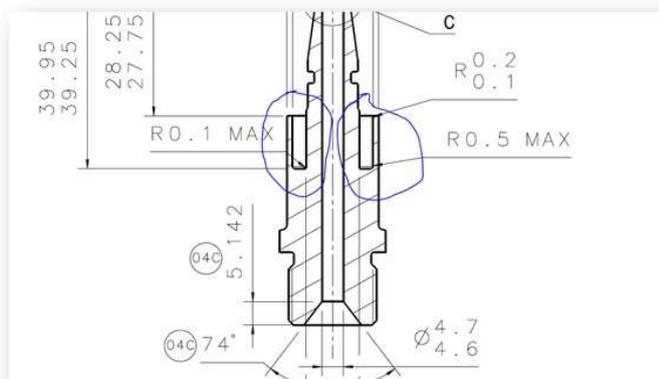
11- **Is there a specific tool used to manufacture the deep groove detail on GIN1756?**

We turned this detail using a “Horn” grooving tool:

- Tool holder: RAH25A.20.1520.02
- Tool tip: S25A.0200.12 TH35

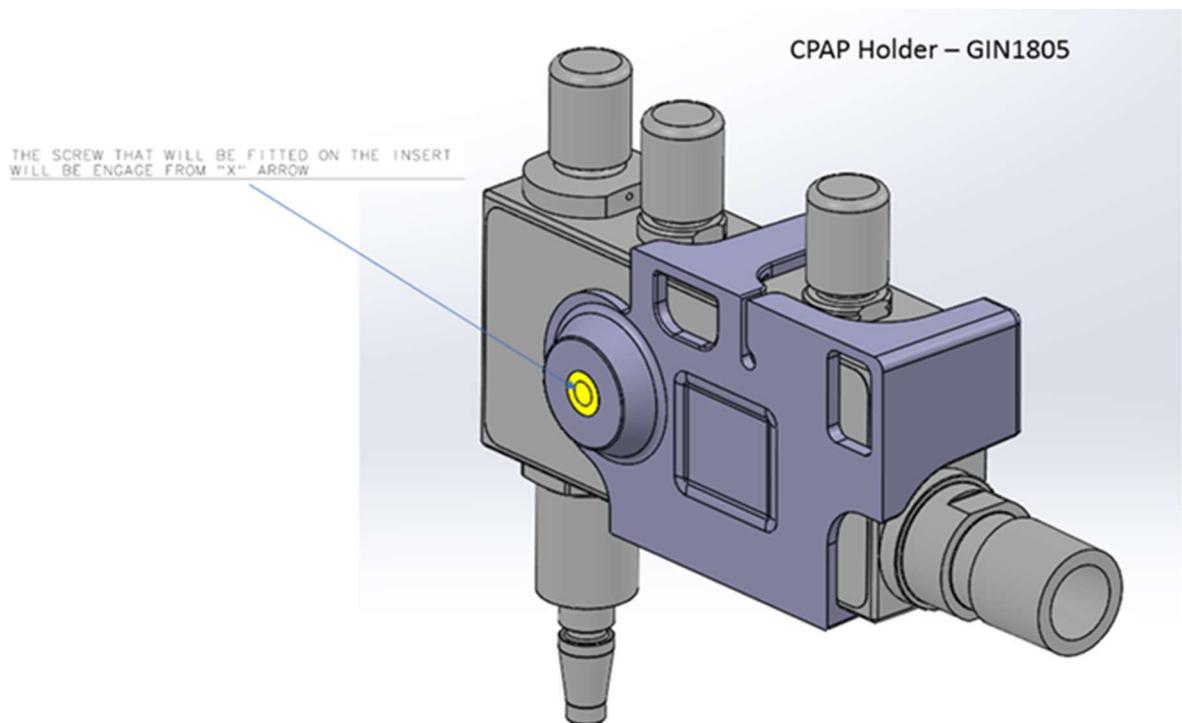
14- **Does GIB2211 need to be made from PEEK material?**

This tool is for help during assembly process, which is used to rotate the needles prior to fitting the circlip.

The material for this needs to be chosen to be strong enough to carry the torque load but soft enough not to damage / mark the needle.

Our assumption would be that even a soft aluminium could cover this application (Aluminium 6082 for example)
